Kansas Department of Agriculture
Division of Water Resources
PERMIT OF NEW APPLICATION WORKSHEET

RE: Application, File No. 50,310

Re: Appropriation Application No. 50310 – Woodard, LLC

APPLICATION REVIEW INFORMATION

Figure 6 - A hydrograph of the average annual water level measurements taken at EB246A
 Location: SE-NE-SE - SEC. 18, T26S, R1W, Sedgwick County

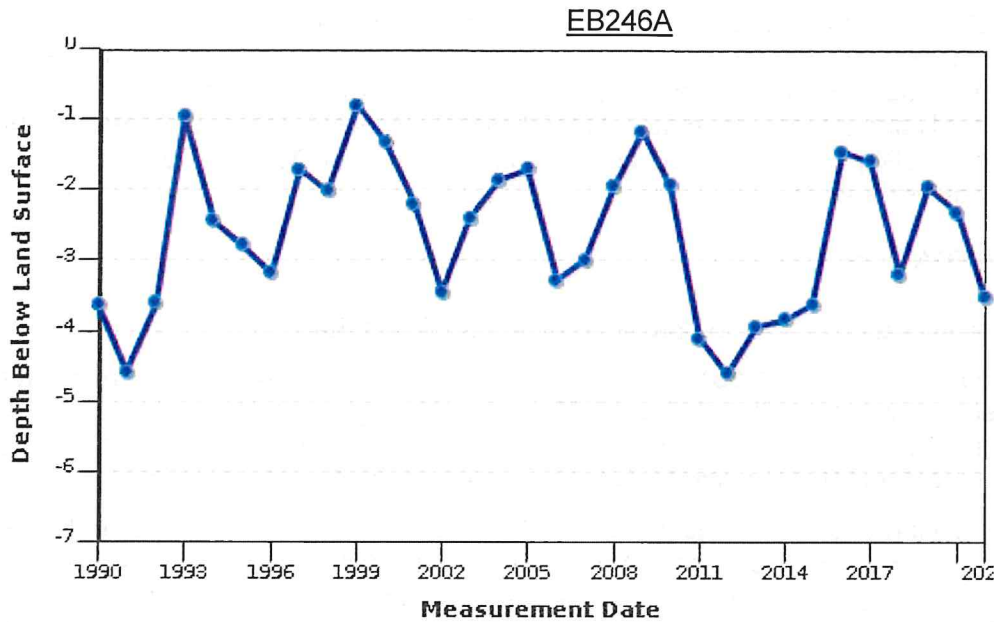
Water level data from Groundwater Monitoring Site EB 246A, located approximately 1.5 miles north of Application No. 50310, recorded water level changes for the period from April 3, 1990, to January 12, 2021 (figure 6). Water levels typically range from approximately 1 to 5 feet below land surface and the water level has been stable and has not shown a declining trend.
